FOR PERCOLATION TESTING AND SITE EVALUATION

PROPERTY LOCATION
SUBDIVISION/PROPERTY NAME Patapsco Overlook LOT NO. Parcel

HOWARD COUNTY HEALTH DEPARTMENT, BUREAU OF ENVIRONMENTAL HEALTH, WELL AND SEPTIC PROGRAM
3525-H ELLICOTT MILLS DRIVE, ELLICOTT CITY, MARYLAND 21043-4544 (410) 313-1771 FAX (410) 313-2648
TDD (410) 313-2323 TOLL FREE 1-877-4MD-DHMH

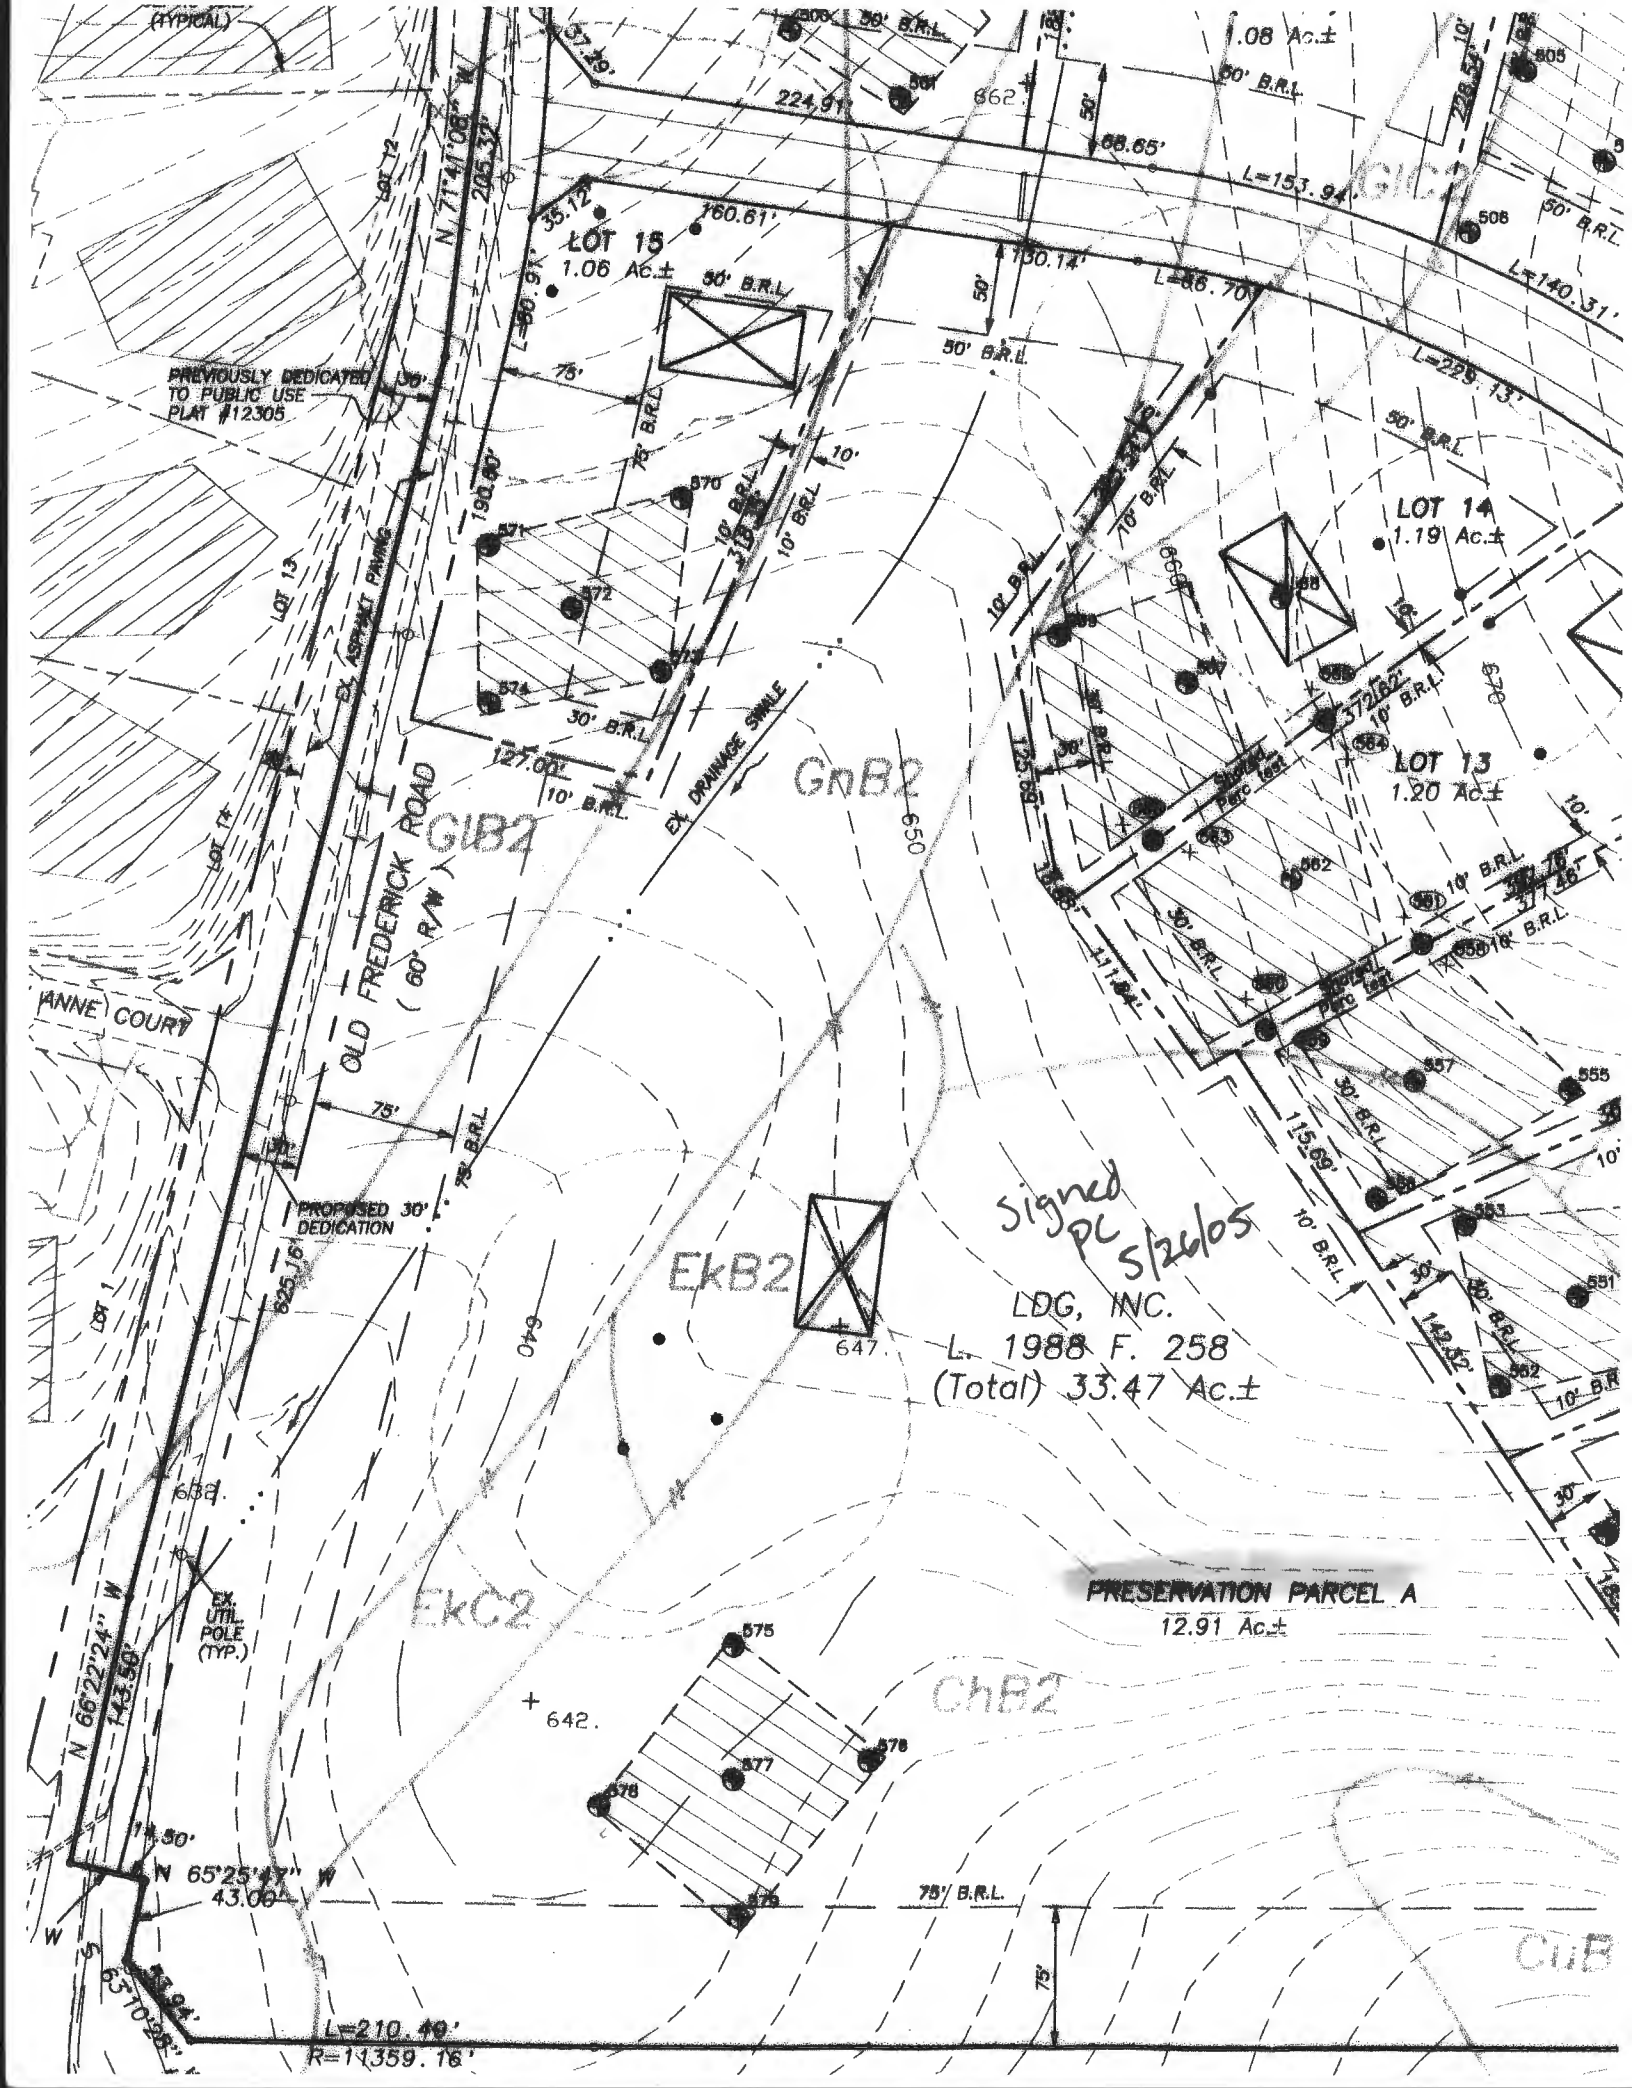
- Need 2 compart. tank detail
- Raise tank
- Raise trenches invert
- Trenches on contour
- Lot lines accurate?
(doesn't match PC)
- down grad wells?
